ADDITIONAL INFO WITH
RESPONSE TO QUESTIONS CONCERNING THEIR
ANALYSIS OF THE TMI-1 REACTOR BUILDING
SPRAY SYSTEM.....2 PG
18 ENCL

Three Mile Island Nuclear Station Unit 1 (TMI-1)
Operating License No. DPR-50
Docket No. 50-289

By letters dated October 13 and November 12, 1975, Metropolitan Edison Company transmitted the results of our analysis of the TMI-1 Reactor Building Spray System. Your letter dated January 20, 1976 requested additional information be provided to permit completion of your review on this subject. The specific information requested and our response are contained below. *

Figure IVa
Metropolitan Edison Company
Three Mile Island Nuclear Station Unit 1
Comparison of Analytical Results to Full Flow Water Test -
Borated Water Storage Tank Drawdown

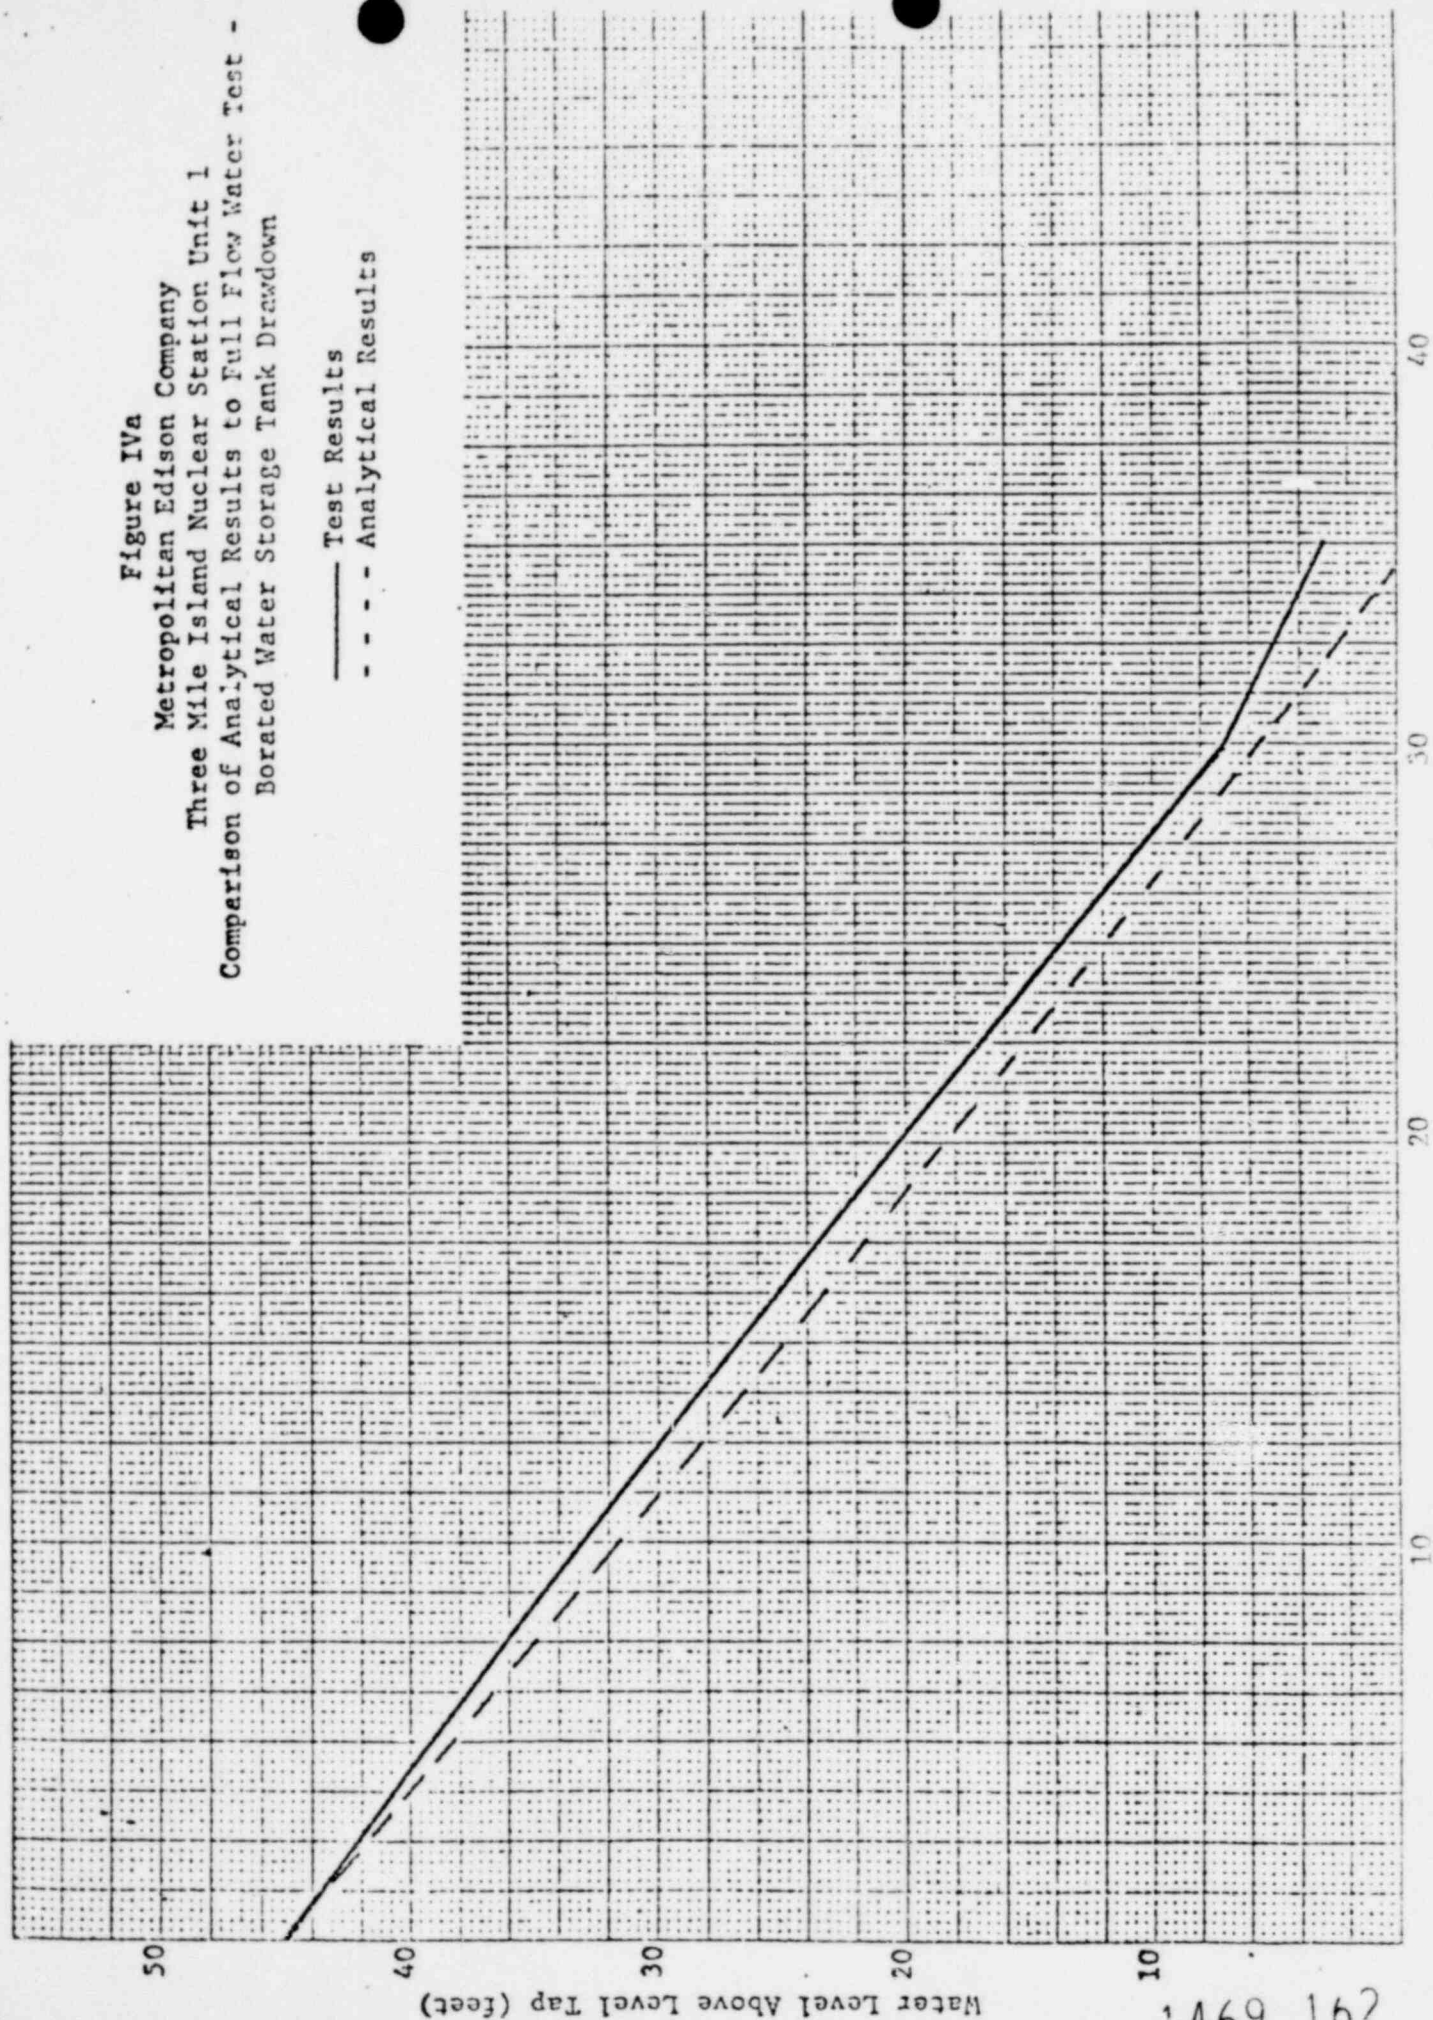
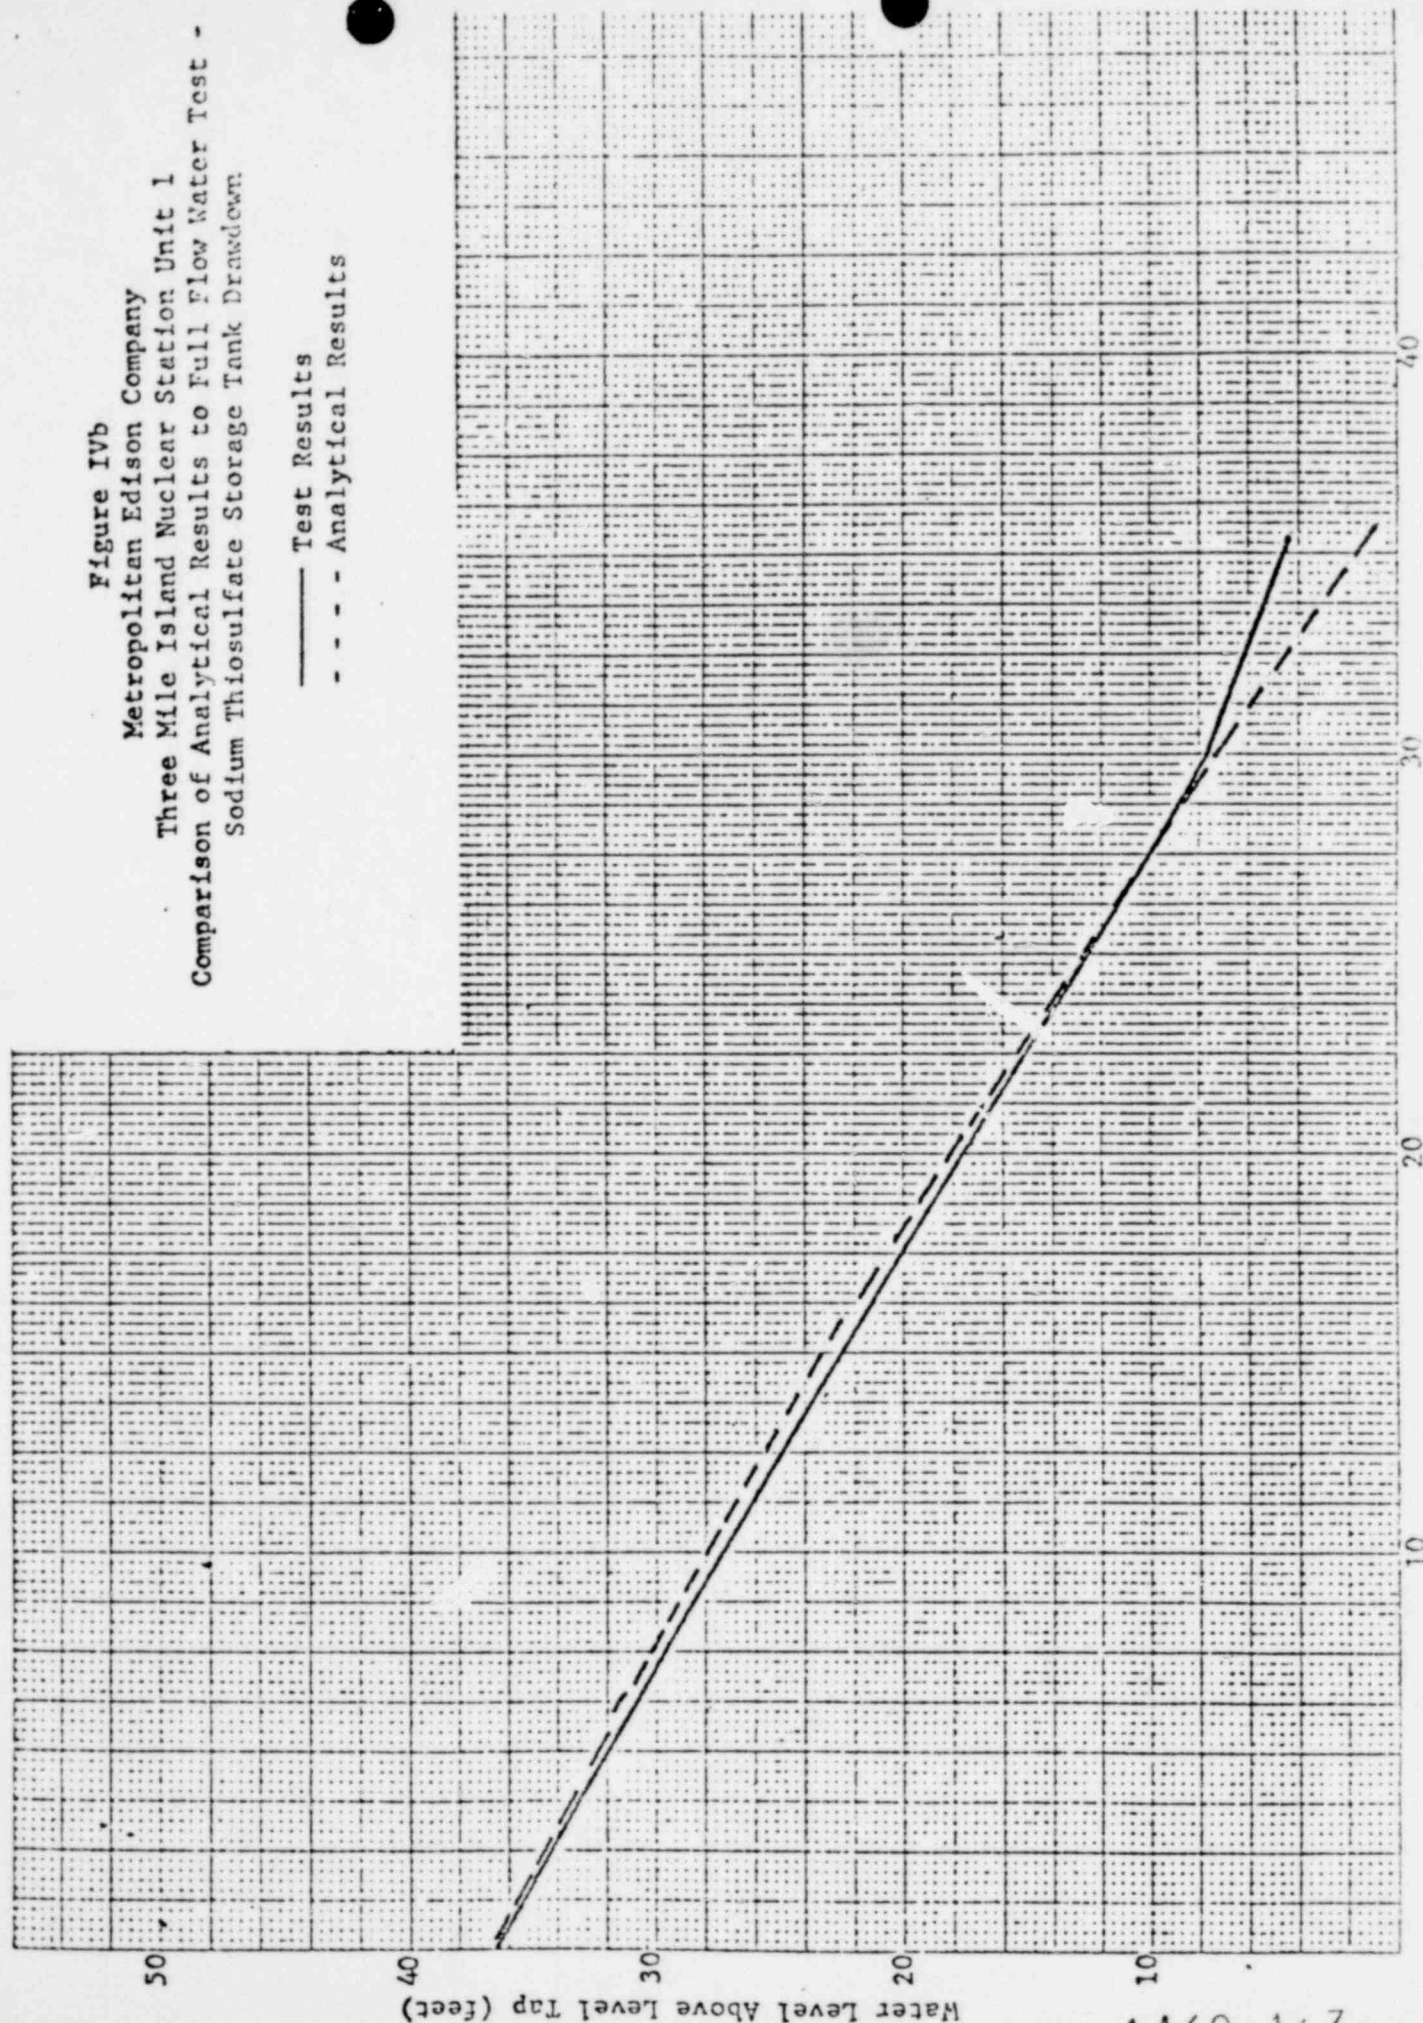
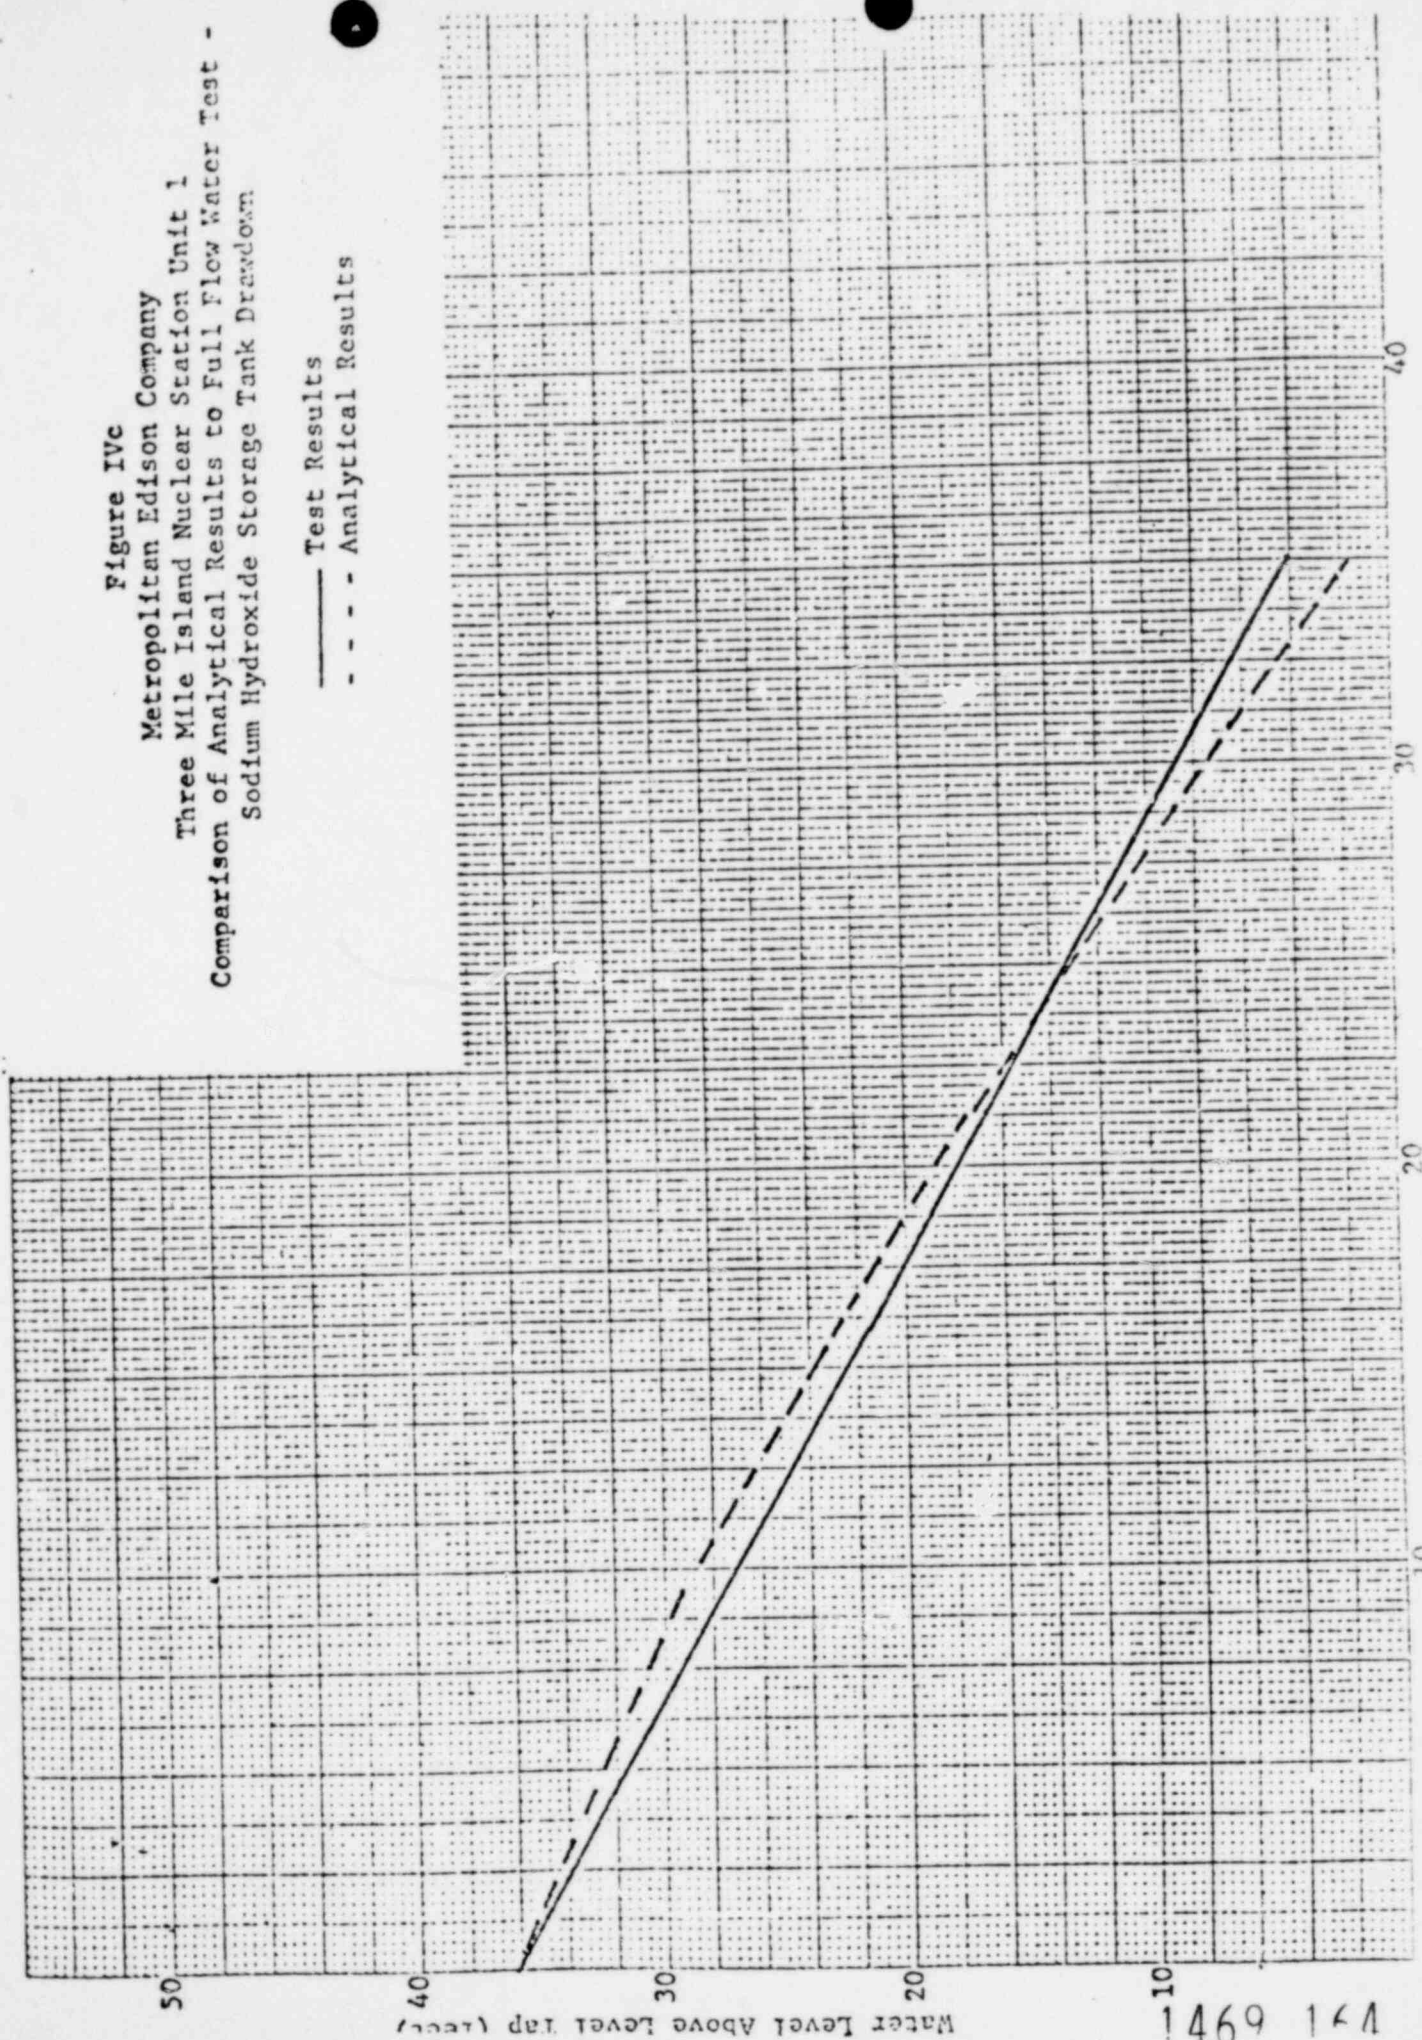
2. Describe and justify the methods used for determining the static pressure head due to the liquid in the BWST, the aspiration force in the spray lines at the chemical tank discharge points, and the friction forces involved.

A comparison of the observed and calculated results of the full flow test is presented in Table I and Figures IV a, b, c. The computer model is shown in Figure II. The calculated level drop per five minutes was comparable to that observed for the three tanks. It should be noted that since a steady state analysis is being done, there exists a larger discrepancy between the observed and calculated results during the startup of the test. The discrepancy at the end of the test is due to the manner in which the liquid levels were recorded; the automatic print-out device used was set to record the levels every five minutes. When the LO-LO level alarm in the BWST was tripped, the pumps were throttled to terminate the test. The liquid levels and time were not recorded; the levels were recorded at the end of the five minute interval, thereby causing the tail-off shown in Figures IV a, b, and c. Test personnel stationed by the pumps heard no indication of cavitation or vortexing during the tests.
